PRODUCT CHANGE NOTIFICATION (PCN)

V2031x
CPU heat sink, forged, pin fin

CHANGE NOTIFICATION: PCN-20220222 V2031x

DESCRIPTION OF CHANGES: CHANGE OF PRODUCT LOCATION
CHANGE OF DATA SHEET
New Draw.-No. ASS 0814 HSrev05

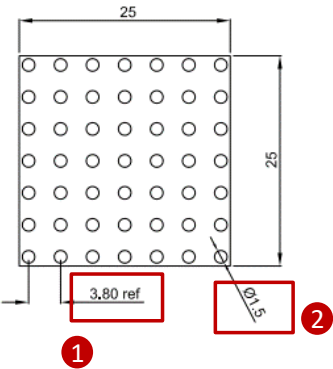
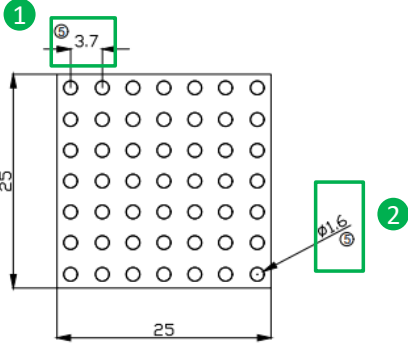
REASON FOR CHANGE: CHANGE OF PRODUCT LOCATION
CHANGE OF PRODUCT DIMENSIONS, TOLERANCES AND/OR

V2031x OLD VERSION	V2031A NEW VERSION
<p>Dimension</p>  <p>Material:</p> <p>③ NOTES: ④ 1.MATERIAL: AL1070. 2.REMOVE ALL SHARP EDGES AND BURR.</p>	<p>Dimension</p>  <p>Material:</p> <p>③ NOTES: ④ 1.MATERIAL: AL1050 H24. 2.REMOVE ALL SHARP EDGES AND BURR.</p>
<p>FOR DETAIL, PLEASE TAKE ATTACHED NEW DRAWING: ASS_0814_HSrev05 FOR REFERENCE</p>

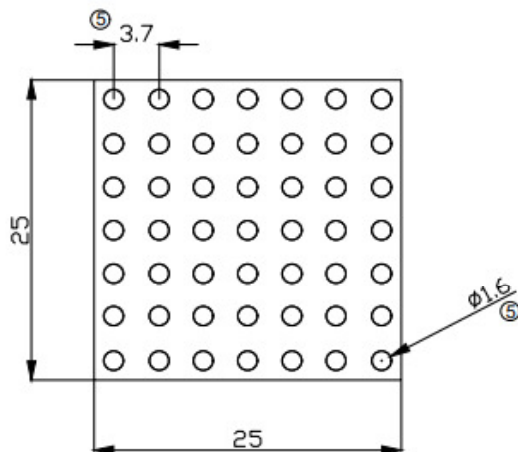
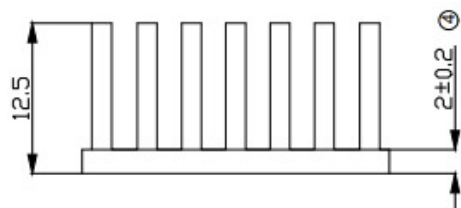
Scale	Free					Date	Name	Customer-No.
④ TOLERANCE	⑤	Update dimension and note	22.02.2022	Daniel	Drawn	05.05.2009	Rale	ASSMANN WSW-No. V2031x
Unit	±0.5	④ Update	22.06.2018	Segal	Approved	22.02.2022	Daniel	
		③ Tolerance add	27.06.2011	Jason				Drawing-No. ASS 0814 HS rev05
DIM	TOL	② Modify drawing layout	10.03.2010	Alex				
		① Drawn	05.05.2009	Rale				Replace Sheet
Angle	TOL	Id.	Modification	Date	Name

NOTES:
 ⑤ 1.MATERIAL: AL1050 H24.
 2.REMOVE ALL SHARP EDGES AND BURR.
